UNITED STATES PATENT AND TRADEMARK OFFICE

09/994,741

Office Action Summary

DETAILED ACTION

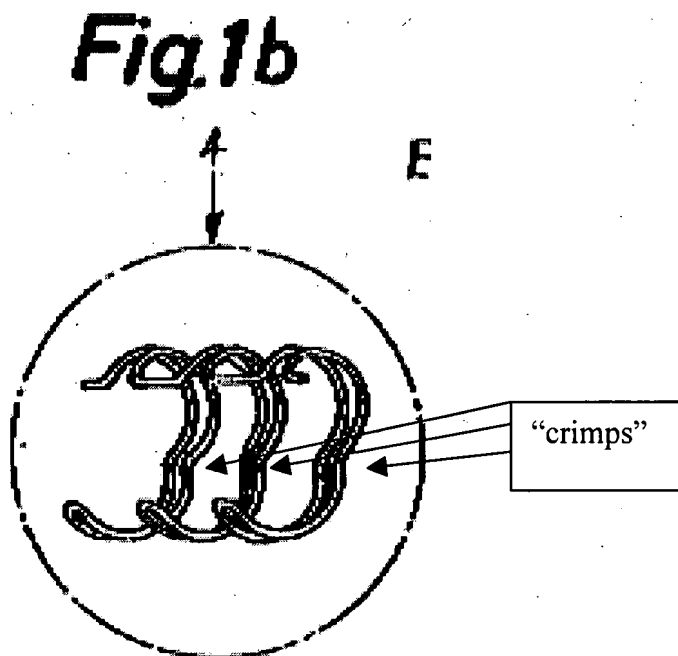
Re claim 3, it is noted that at least the section so indicated in the reproduction of Figure 1b below can be considered to be a “crimp” that is “formed” in a loop of the looped binding element.

Re claim 4, it is noted that there are a "series" of such crimps as shown in the above reproduction of Figure 1b.
